Benedick Holdings, LLC  
Annexation and Zone Change

Exhibit K-58 B1  
Planning Commission Testimony

LAND USE APPLICATION  
Preliminary Subdivision

For Office Use Only: FILE # PA105821 CODE: DASUB

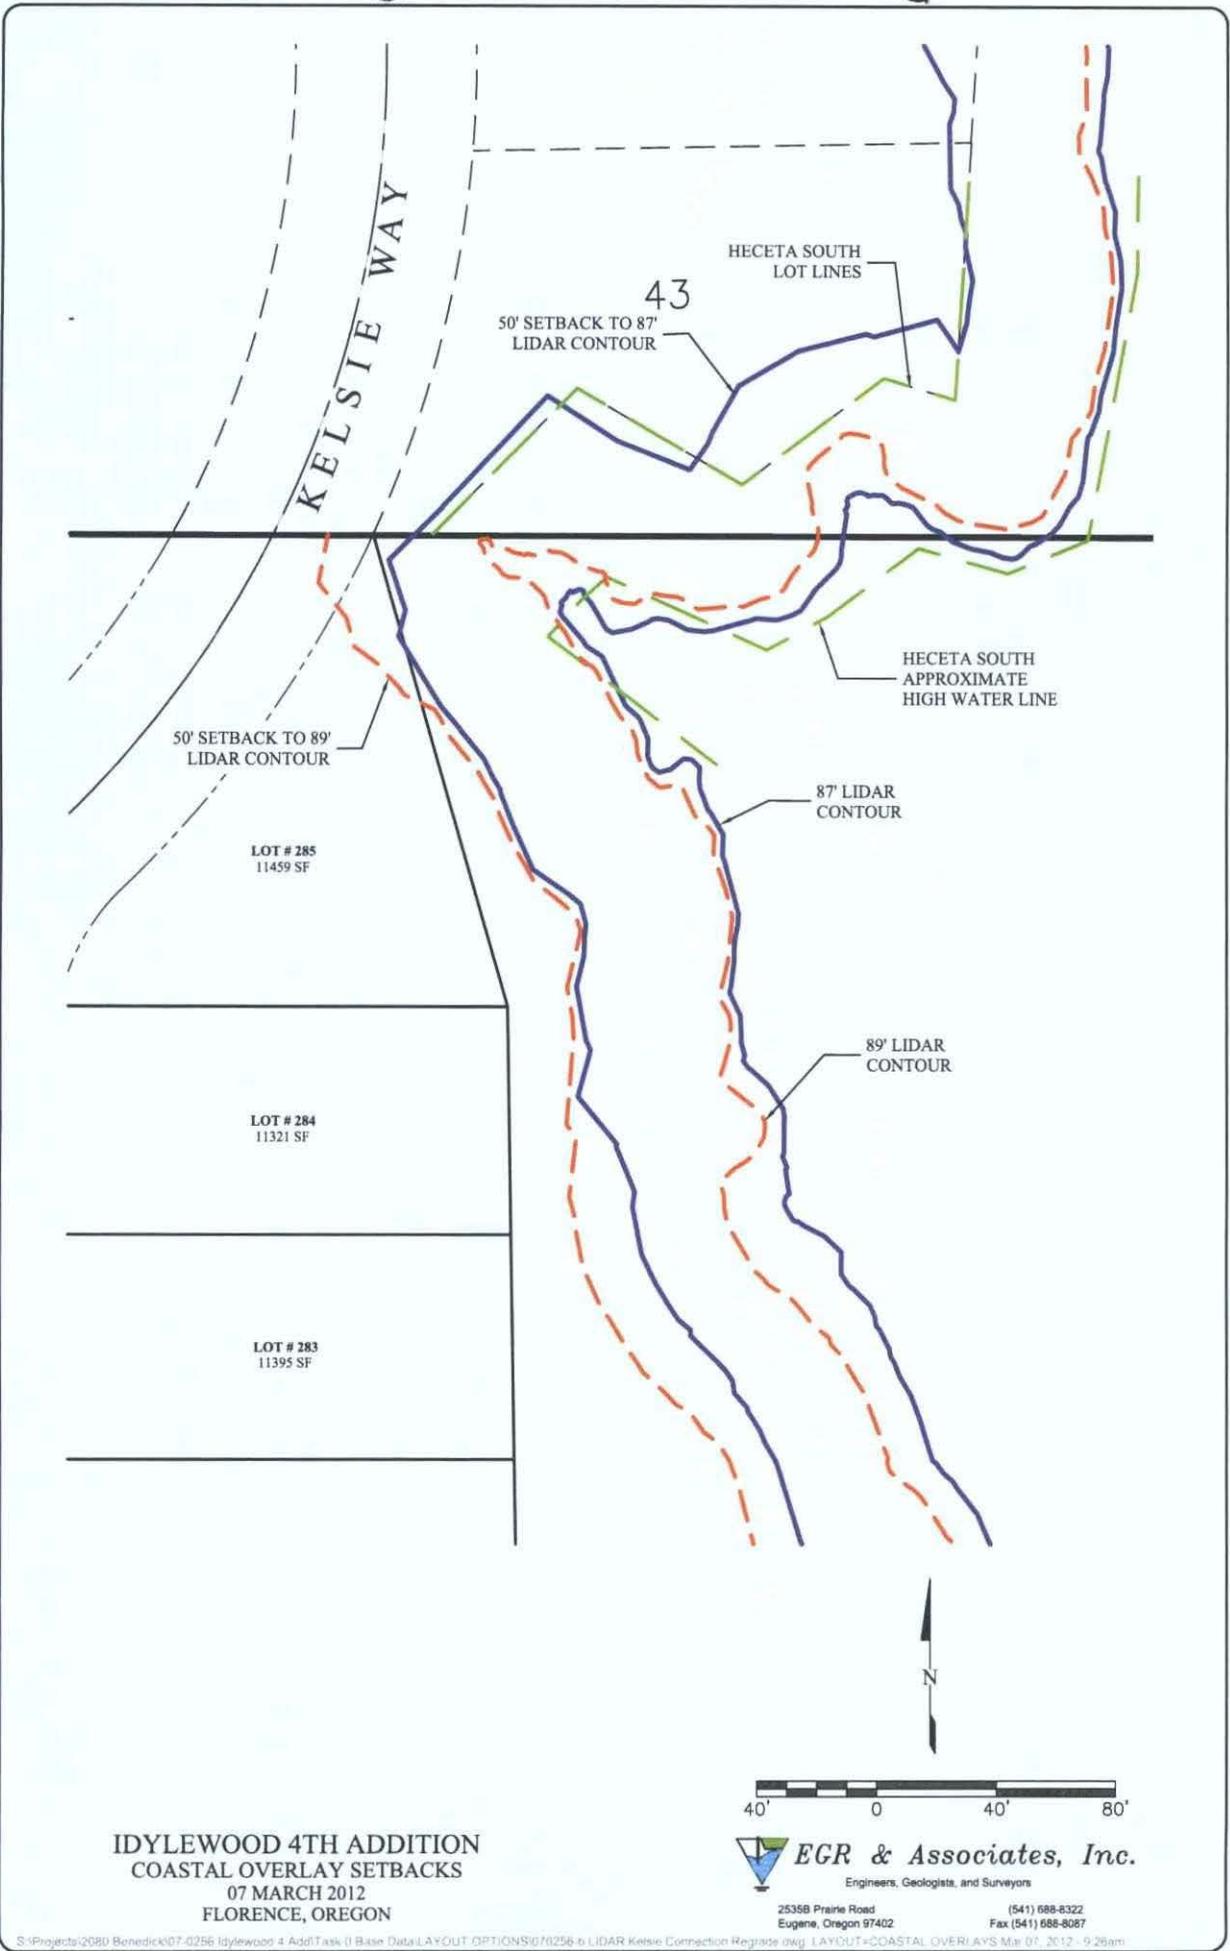
As we have discussed, the lake does not appear to have a surface outlet until the water level reaches approximate elevation 87' msl, at which elevation a surface outlet forms to the south on the County property. This elevation will regulate the seasonal high water level to a maximum elevation of 87' msl. As shown, the 50-foot setback line (also shown as blue) from the 87' contour line lies outside the proposed Kelsie Way right-of-way on the Idylewood property. Note that the 87' contour and associated 50-foot setback line correlates well with the high water line and setback shown on the Heceta South subdivision. An extension of Kelsie Way road to the north will not result in any grading occurring within this 50-foot setback area.

The 89' LIDAR contour (shown as red) corresponds to the approximate high lake level that occurred during the February 1996 flood event based on visual observations. This high lake level was temporary due to rising groundwater and surface water from heavy rainfall that occurred over several weeks and represents a flood condition, not a seasonal high water level. As shown, a 50-foot setback (also shown as red) from the 89' contour extends into the Kelsie Way right-of-way on the Idylewood property. An extension of Kelsie Way road to the north will result in a cut slope occurring within this 50-foot setback area. The 89' contour and associated 50-foot setback line does not correlate as well with the high water line and setback shown on the Heceta South subdivision as the 87' contour and setback.

# Figure 5-1: Florence Northwest Region

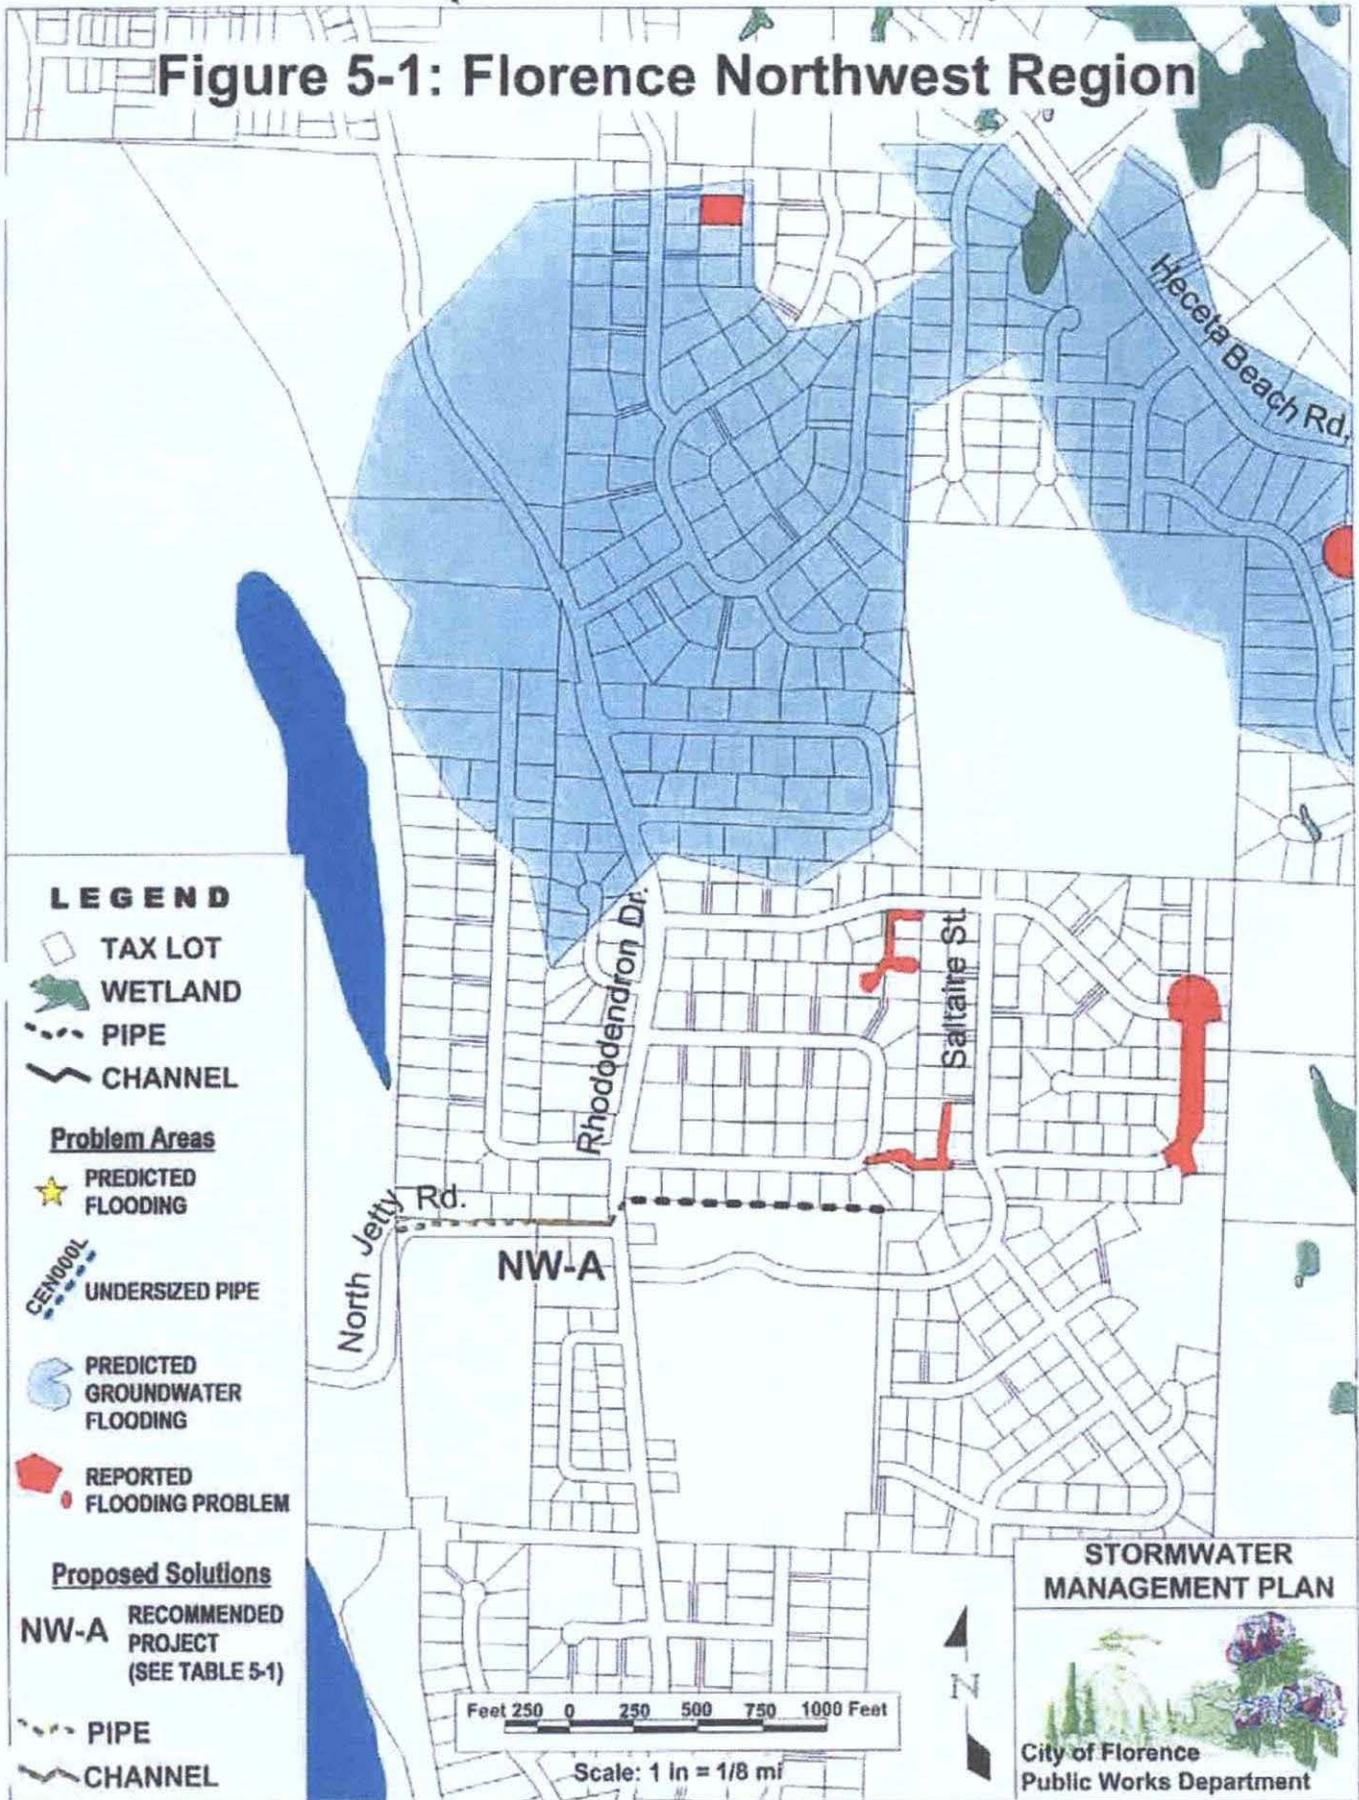
Fig 5-1?

water escape routes

← define "negative effect"

public roadsides. The questions here are, where is the route and final destination of the drainage water, can the conveyance route handle this additional runoff, and are there private maintenance provisions for the lots using pumpstation in the CC&Rs? Thus, as a condition of approval, or prior to the final plat these questions shall be addressed by the applicant's engineer.
